# 25-55DA Venice Isle Staff Report

<b>Address:</b>	256 Nokomis Ave. South
<b>Request:</b>	Request for relief from Chapter 87 Section 4.5 for perimeter buffer, Chapter 87 Section 3.1.8.1.B.1.a center of drive to property line distance, and Chapter 87 Section 2.3.5.1 for setbacks.
<b>Owner:</b>	Venice Isle LLC
<b>Agent:</b>	Beka Saldadze (B Design LLC)
<b>Parcel ID:</b>	0408-12-0060
<b>Parcel Size:</b>	±.379 acres
<b>Future Land Use:</b>	Mixed Use Downtown (MUD)
<b>Zoning:</b>	South Trail 1 (ST 1)
<b>Comprehensive Plan Neighborhood:</b>	Island
<b>Application Date:</b>	April 18, 2025
<b>Related Applications:</b>	25-13 SP

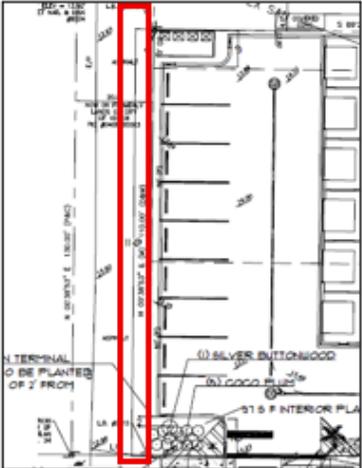
**Justification for Design Alternative to Chapter 87 Section 4.5:** Along the west property boundary, a Type 1 perimeter buffer is required by LDC code Chapter 87, Section 4.5. However due to the proposed building design, property layout and required parking, only a 2’ perimeter buffer is provided and a design alternative is requested.

Chapter 87, Section 4.2.B notes that the intent of a perimeter buffer is to mitigate and screen the property from adjacent properties and public right-of-way. For the last few decades there have been no buffer between the existing building and the building to the west. This project looks to completely change the appearance of the property, maximize the number of residential units and also include a commercial component to the property that did not exist before. The proposed project includes a small landscape buffer to the west, however due to the layout of the property and building it is smaller than required by the current LDR and the building cannot be shifted or adjusted to meet this buffer requirement as well as all the other City of Venice code requirements. However, this alternative layout still provides some buffer to the adjacent property that did not exist for the last few decades.

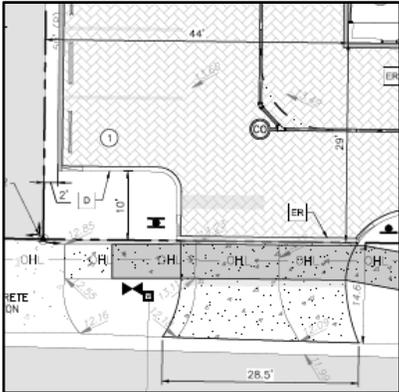
**Justification for Design Alternative to Chapter 87 Section 3.1.8.B.1.a:** A second design alternative includes the distance from the center of the drive to the property line.

Per LDR Chapter 87, Section 3.1.B.1 the required offset from the center of the drive to the edge of the property is required to be 20’ for non-residential and mixed-use districts. This project proposes an alternative design of 17’ from the center of the drive to the property line. While this offset is slightly smaller than required, there is still an adequate landscape buffer prior to

the sidewalk and will not negatively affect the aesthetics of the property. Due to the layout of the building, required parking and other code requirements, the driveway could not be shifted further away from the property line without impacting the setback distance on the other side of the property.

**Summary Staff Comment:** The proposed project is on a small parcel, which makes providing required parking and associated buffers while maximizing the development a potential challenge. Chapter 87 Section 2.3.2.D allows for a design alternative to be requested for building placement/setback in a mixed use district, which is consistent with the design alternative request for the side and rear setbacks. In the current state the property does not have a buffer along the west side of the property. Upon further review the requested design alternative for the drive aisle is not necessary as it is currently over 20' on the site plan.

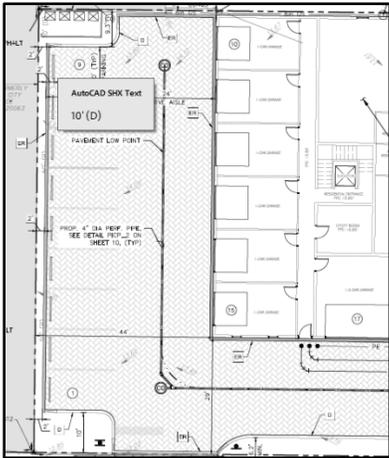
**Justification for Design Alternative to Chapter 87 Section 2.3.5.1:** A third design alternative includes the maximum rear and side (south) setback distance. Per LDR Chapter 87, Section 2.3.5; The maximum rear setback dimension is 20'. The proposed project has a maximum rear setback of 44'. Due to the layout of the building and required parking spaces, the building was set at the minimum front setback dimension of 5' and the rear corner of the building is 44' from the property line. The building cannot be shifted further to the west due to the required drive isle and parking spaces that come within 2' of the rear property line. While this dimension is greater than the Land Development Code allows, the max. rear setback is similar to the existing building that has been there for decades and this proposed project does not distract from the surrounding properties. Also per LDR Chapter 87, Section 2.3.5; The maximum side setback dimension is 15'. The proposed project has a maximum south side setback of 29'. Due to the layout of the building, driveway width regulation and landscape buffer the building was set at the 29' from the south property line.
